Sent: 5/03/2021 2:11:49 PM
Subject: DA2020/1247 CNR-13920 - AMENDED PLANS FOR UNDERGROUND TANK REPLACEMENT WORKS FOR EXISTING 7-ELEVAN – 940 PITTWATER ROAD, DEE WHY
Attachments: 20210212 - Response to TfNSW - Dee Why Petrol.pdf; swepts 210303.pdf; 20210305 - TfNSW Response SYD20_01230_02.pdf;

RE: DEE WHY 7-ELEVEN PETROL STATION
RESPONSE TO MATTERS RAISED BY TfNSW

**AMENDED PLANS FOR UNDERGROUND TANK REPLACEMENT WORKS FOR
EXISTING 7-ELEVEN – 940 PITTWATER ROAD, DEE WHY**

VEHICLE TURN PATHS

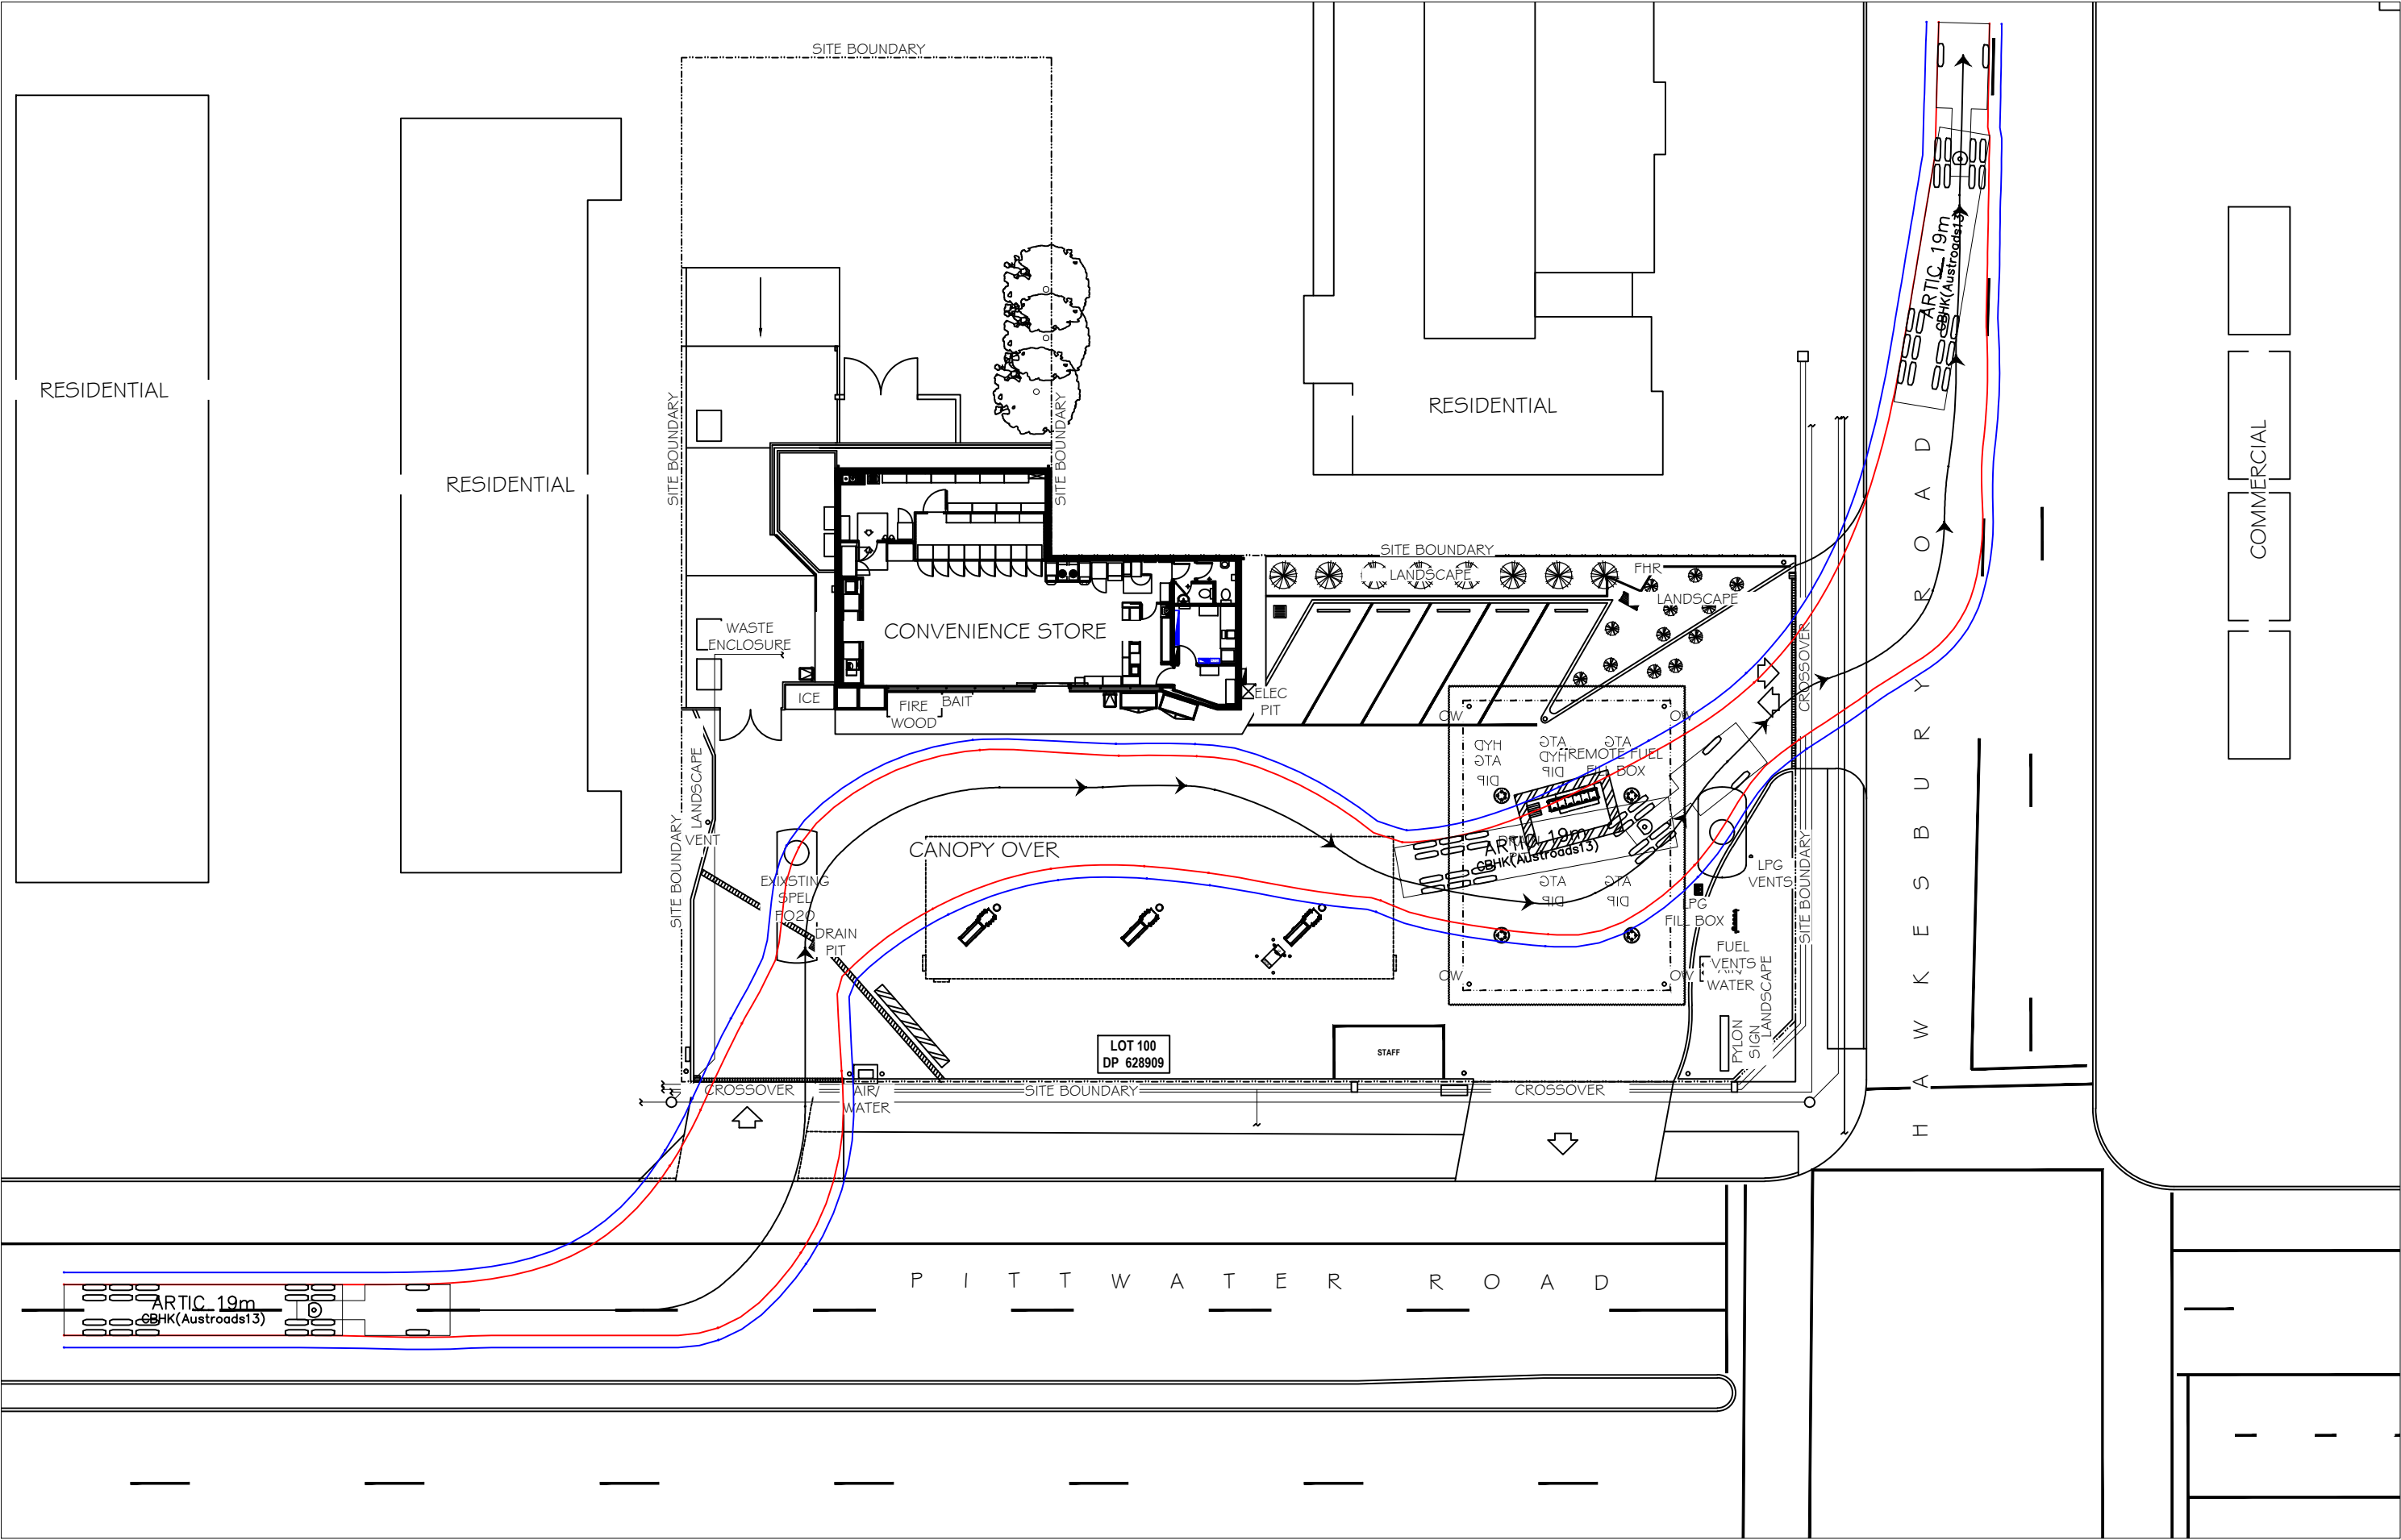
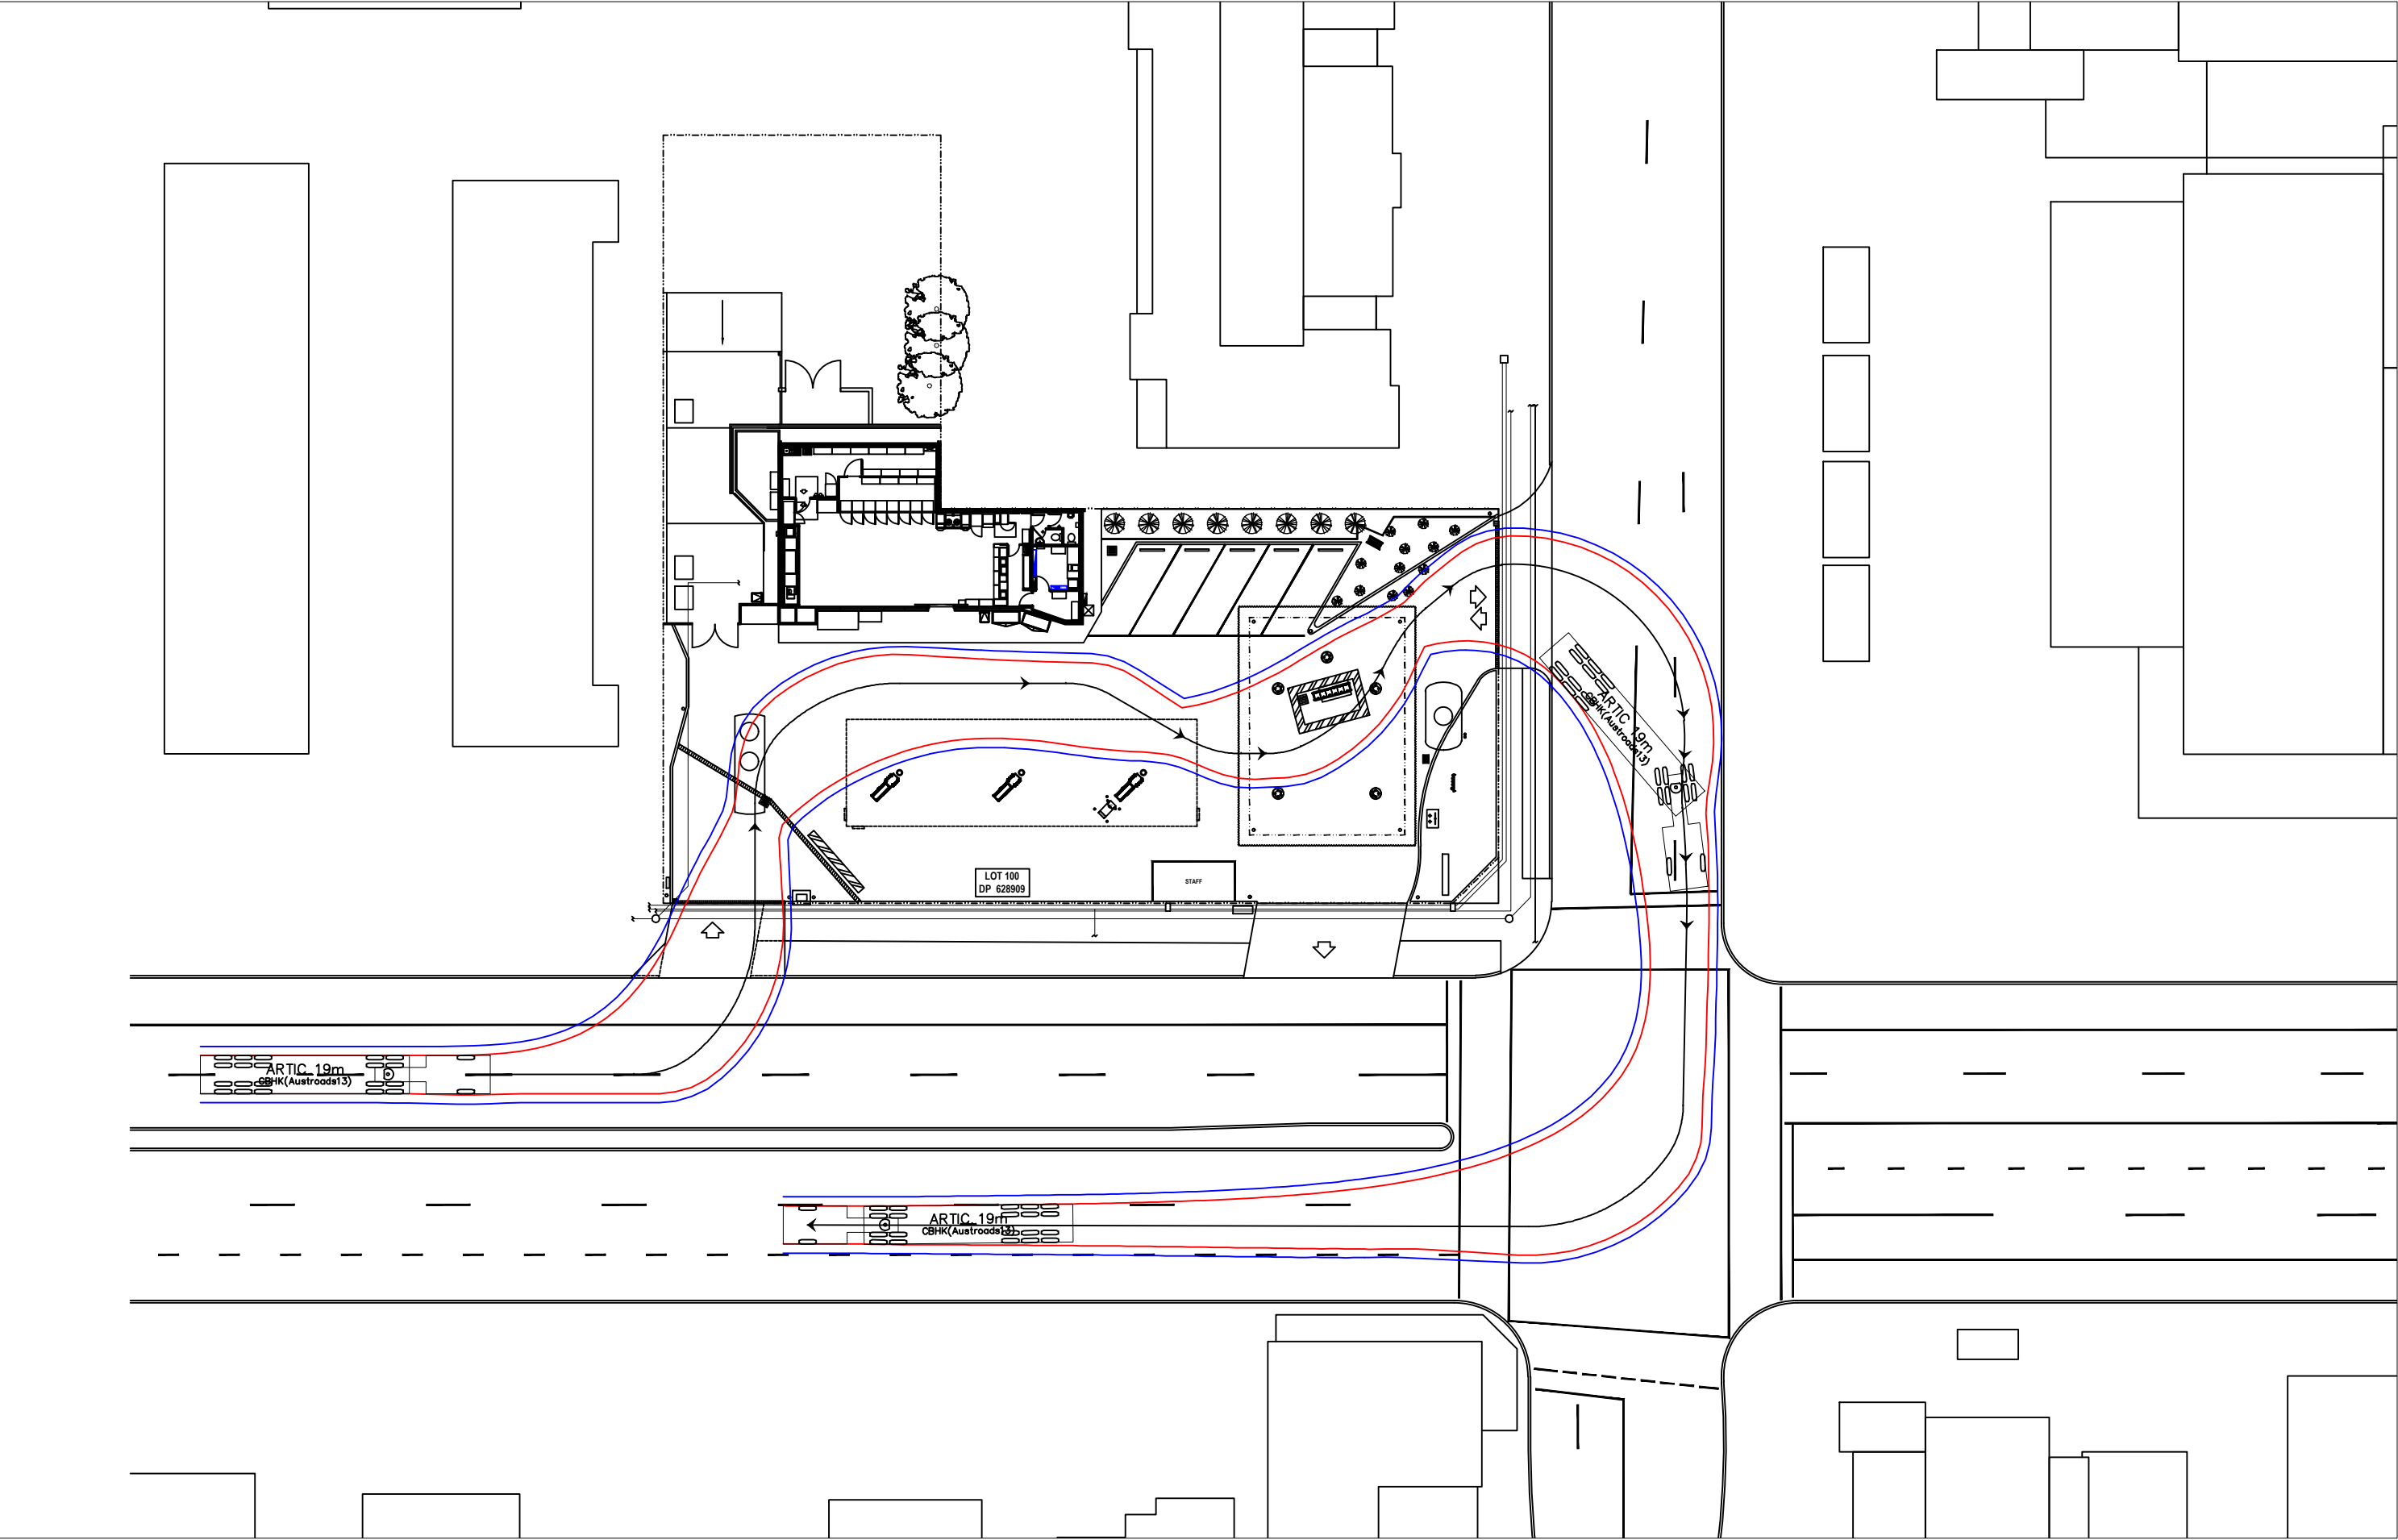
- ii. *Another option might be for the proponent to consider widening the first entry driveway on Pittwater Road for the tankers. However, this depends on whether the swept path analysis demonstrates that tankers can enter on Pittwater Road and exit on Hawkesbury Road in a forward direction*

3. Delivery tanker shall enter the site via the northern entry on Pittwater Road and exit via Hawkesbury Avenue as shown on the swept path plans provided. Vehicle over 8.8 meter long shall not enter/exit the site via the southern access point on Pittwater Road.

3. The tanker turn path (showing entry from the northern driveway (left turn from Pittwater Road and exit via a left turn onto Hawkesbury Avenue) is provided in Attachment B.:
